REQUEST FOR PROPOSALS No. 25-017

NBPCC Final Effluent Chamber Piping Bypass Pumping Plan

Addendum 1

Addendum 1a Responses to Vendor Questions

Addendum 1b
Reference drawing

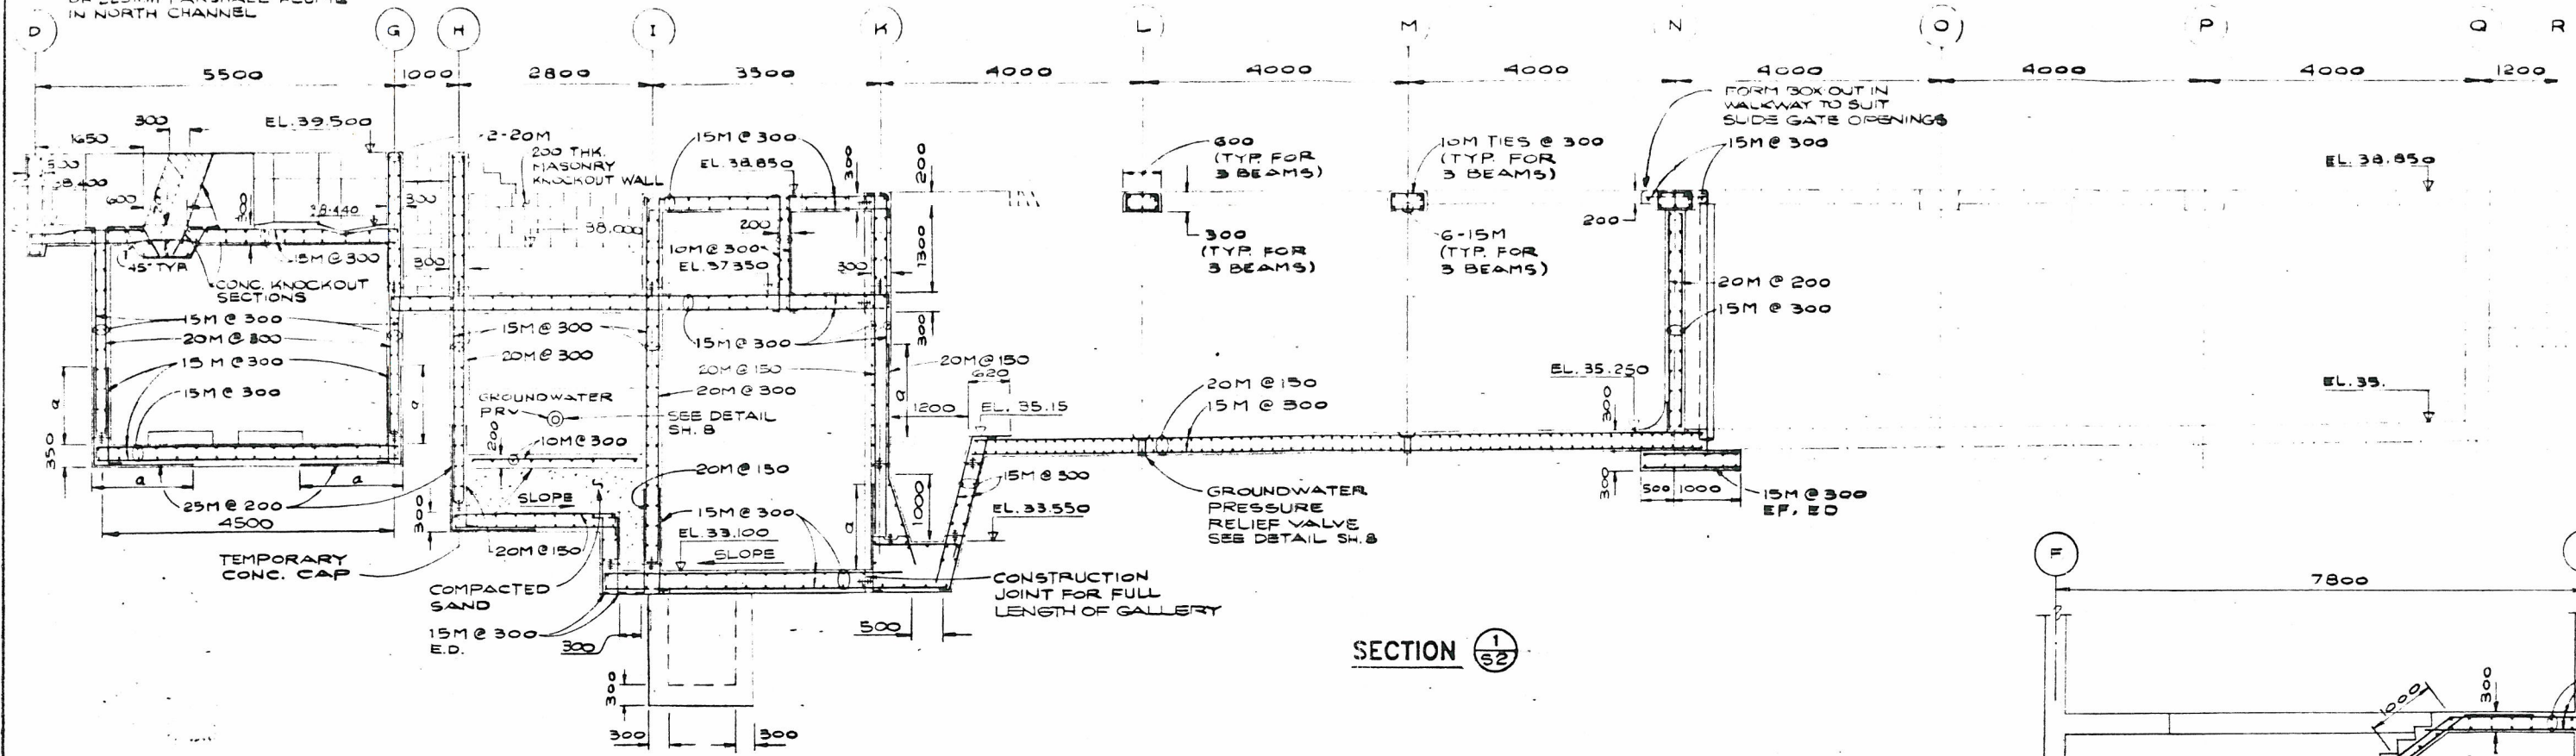
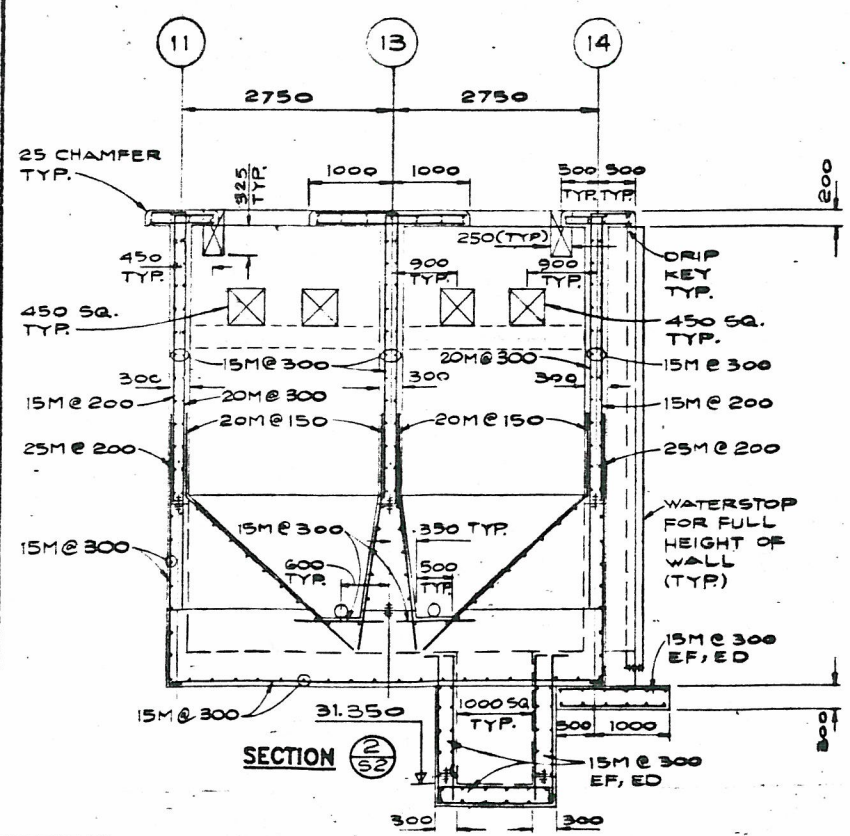
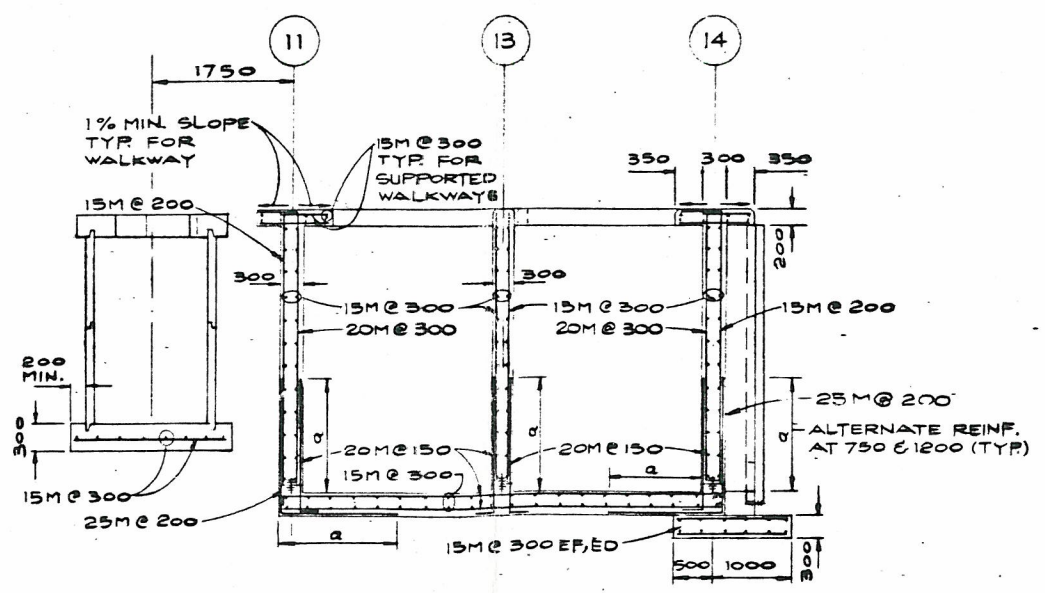
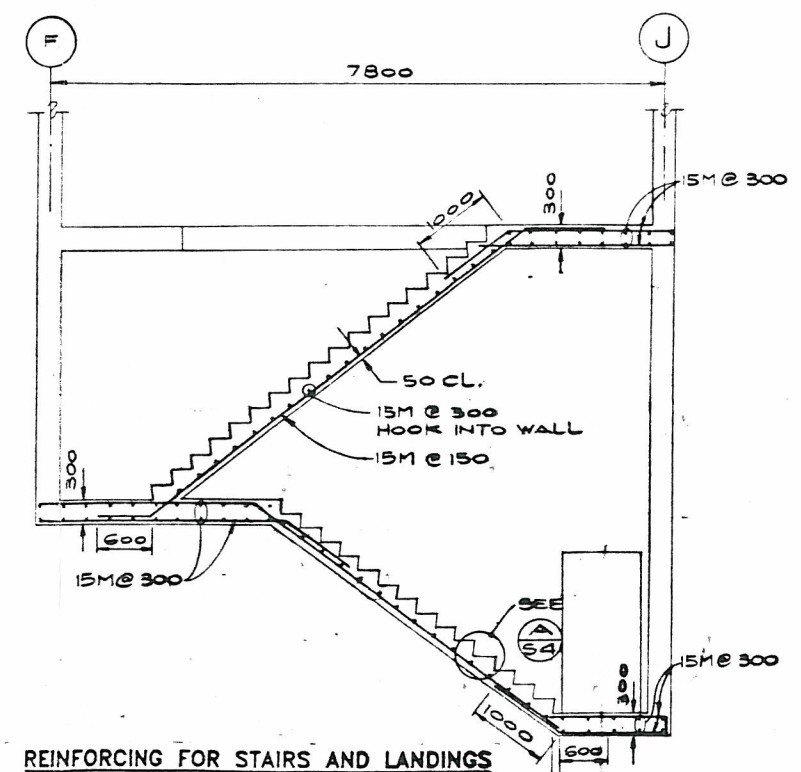
1. **Question:** What is the depth of this tank? Elevations at ground and bottom of tank?
Answer: *Please see attached drawing, NB-S-104 which speaks to elevations*
